BAR 19-09-06  
205 2<sup>nd</sup> Street SW, Tax Parcel 280078000  
Chauncey Hutter, Owner/Applicant  
Roof replacement

**CITY OF CHARLOTTESVILLE  
BOARD OF ARCHITECTURAL REVIEW  
STAFF REPORT  
September 17, 2019**

**Certificate of Appropriateness Application**

Roof Replacement

Shed Roof

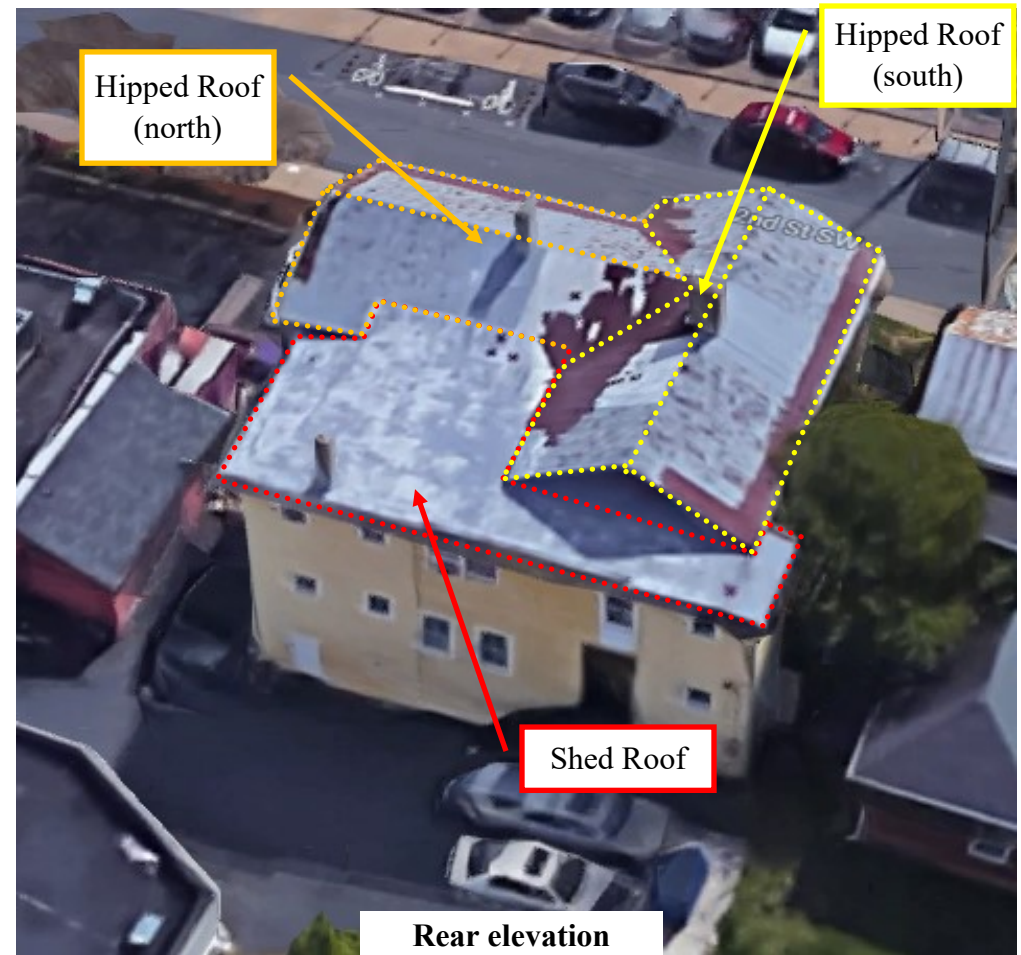
**Motion: BAR Member Carl Schwarz moved having considered the standards set forth within the City Code, including City Design Guidelines for Rehabilitations, I move to find that the BAR approves the replacement of only the area labelled “shed roof” on the diagrams that staff has provided with an alternative material, recommended membrane-style roof due to its low slope, and that the remaining roof area shall be replaced with metal to match what is currently there, matching in pan width, seam height and with no large commercial ridge cap, and with the retention of Philadelphia-style gutters, and with that, this application satisfies the BAR’s criteria and is compatible with this property and other properties in the Downtown ADC district and that the BAR approves this application as modified  
Breck Gastinger seconded. Approved (9-0).**

- Hipped Roof (south): Existing is standing seam, painted metal with Philadelphia gutters.
- Hipped Roof (north): Existing is standing seam, painted metal with Philadelphia gutters.
- Bay Window: Existing is flat seam, painted metal with Philadelphia gutters.
- Front Porch: Existing is flat seam, painted metal with Philadelphia gutters.
- Shed Roof (at rear): Existing is flat seam, painted metal; gutter type uncertain.

Replacements of the shed roof components on the rear additions with an alternative to metal would be acceptable—either membrane or asphalt, provided that the low pitch would allow use of the latter. Eave-mounted gutters would be acceptable.

Replacement of the two hipped roofs, the bay window roof, and the front porch roof with standing-seam or flat-seam metal matching or similar to the existing. The preference would be to retain the Philadelphia gutters, however the BAR has allowed replacement on a case-by-case basis. Staff recommends that the Philadelphia gutters on the bay window roof and the front porch roof be retained/replicated.
